**TOWN OF GLASTONBURY
ADDENDUM #2
SLOCOMB PROPERTY SOIL REMEDIATION
BID #GL-2013-35**

ADDENDUM 2

ANTI-TRACKING PAD DETAIL

J.T. SLOCOMB COMPANY
68 MATSON HILL ROAD
GLASTONBURY, CONNECTICUT

**CONSTRUCTION ENTRANCE/ANTI-TRACKING PAD
NOT TO SCALE**

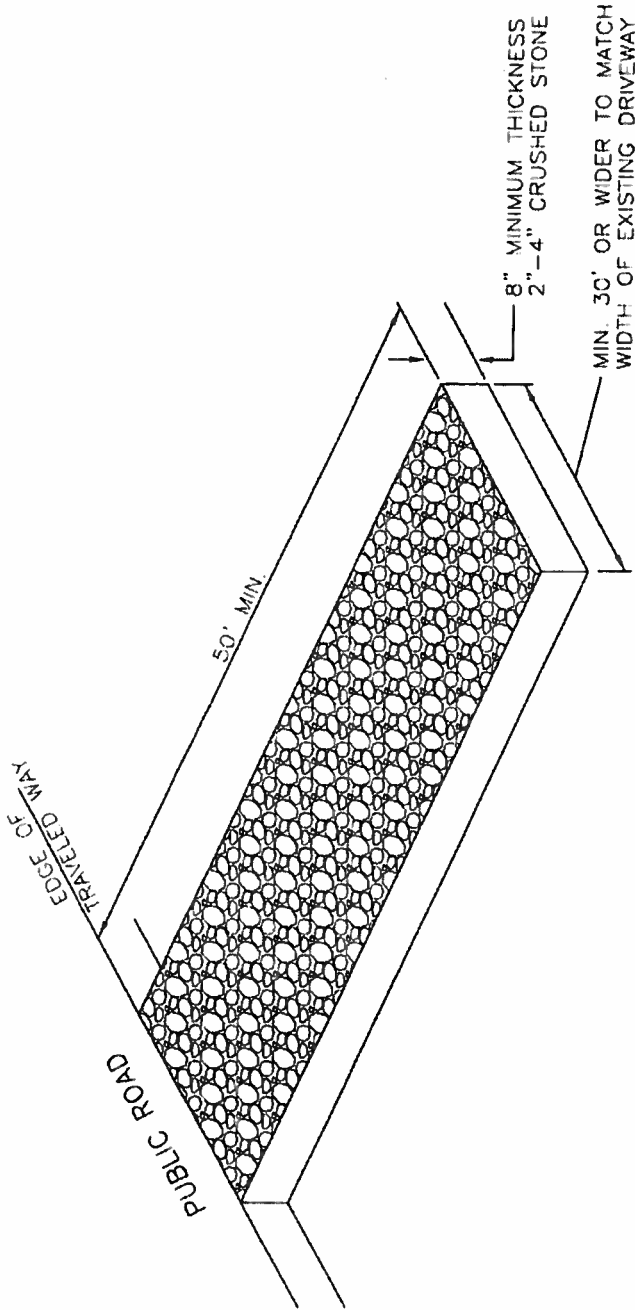
4. What is the linear footage of the "Erosion Control"? **Estimated to be 765 linear feet.**
5. How big is, and are there any specs, on the "Anti-Tracking Pad"? **Please refer to the new detail posted.**

1. CLEAR AND GRUB AREA BEFORE PLACEMENT OF STONE. A GEOTEXTILE LAYER MAY BE USED TO STABILIZE POOR SUBGRADE SOILS.
2. PROVIDE FOR POSITIVE DRAINAGE OF SEDIMENT LADEN WATER THROUGH AN APPROVED SEDIMENT FILTER OR TO A SEDIMENT BASIN.
3. MAINTAIN ENTRANCE SO AS TO PREVENT TRACKING OR FLOWING OF SEDIMENT ONTO PUBLIC ROAD.
4. SHOULD SITE CONDITIONS BE SUCH THAT SOIL CANNOT BE REMOVED BY VEHICLES TRAVELING OVER THE PAD, THE TIRES OF VEHICLES MAY HAVE TO BE WASHED PRIOR TO VEHICLES ENTERING THE PUBLIC ROAD. ALL WASH WATER SHALL BE DIRECTED THROUGH AN APPROVED SEDIMENT FILTER OR TO A SEDIMENT BASIN.
